HDVS® Display

Subject: **FLICKERING SCREEN WITH 220V/50Hz
LINE VOLTAGE**

Model: **HDM-1230**

Figure 1

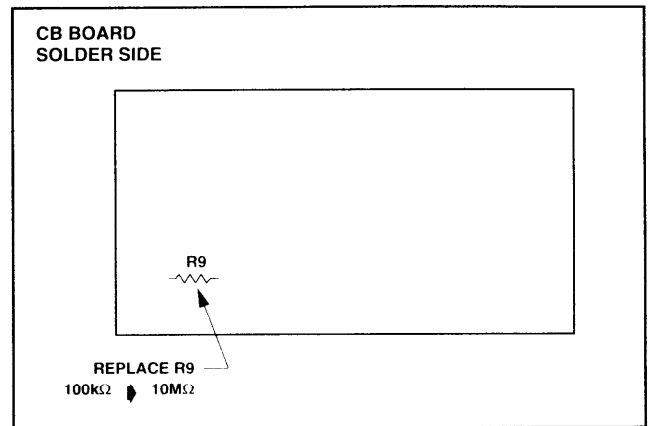
When 220V/50Hz line voltage is used, flickering may occur on a dark screen. If this occurs, replace R9 (100kΩ) on the CB board (solder side) with a new 10MΩ resistor. (See Figure 1.)
